INTERSTATE NUCLEAR SERVICES

Subject: Amendment of License Nos. 37/23341/01 and  
20/03529/01

Enclosed are two copies of replacement pages further updating our applications dated 10/1/87 and 6/15/87 respectively updating the two referenced RAM licenses. Changes have been made in accordance with our telephone conversation of 10/27/87. As we are no longer operating the experimental PVRs system and are not applying under "waste processor" category, hopefully our paid fee of \$1400.00 should be reduced to \$340.00 for amendment of these two nuclear laundry licenses.

Figure B-2

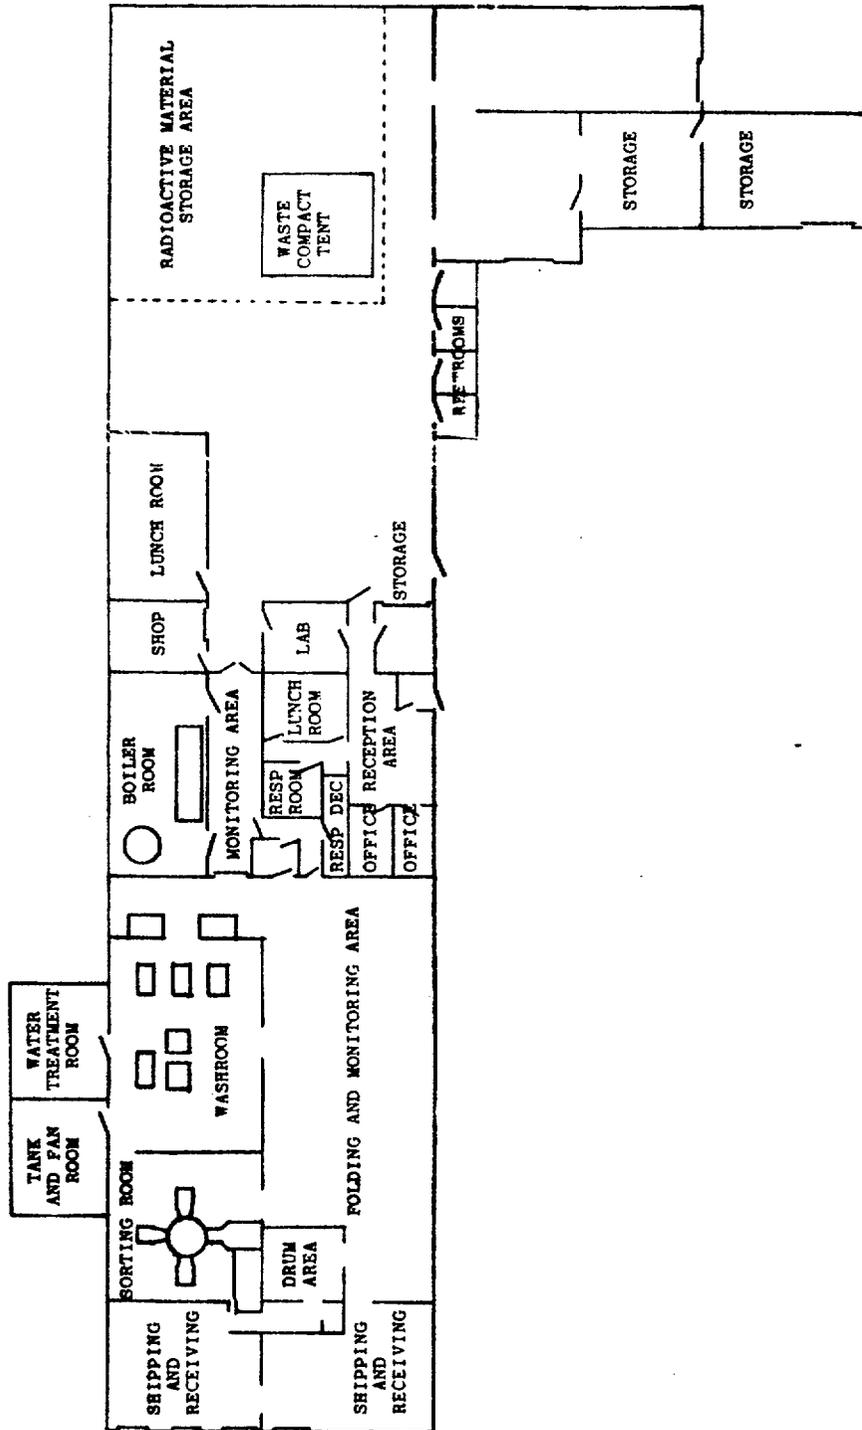
- 1) Substitute page 1 - 3 dated 10/29/87 for pg. 1 - 3 dated 6/15/87 corrected table of contents, possession limits, personnel.
- 2) Substitute page B1 and B2 dated 10/29/87 for page B1 and B2 dated 6/15/87 ;eliminates PVRs
- 3) Substitute page B4 - B6 dated 10/29/87 for pages B4 - B6 dated 6/15/87; updates drawings.
- 4) Substitute pages D13 - D14 dated 10/29/87 for pages D13-D14 dated 6/15/87; corrects typo, adds "at least annually" to HP audits.
- 5) Substitute pages E5 - E17 dated 10/29/87 for pages E5 - E25 dated 6/15/87 - updates personnel resumes.
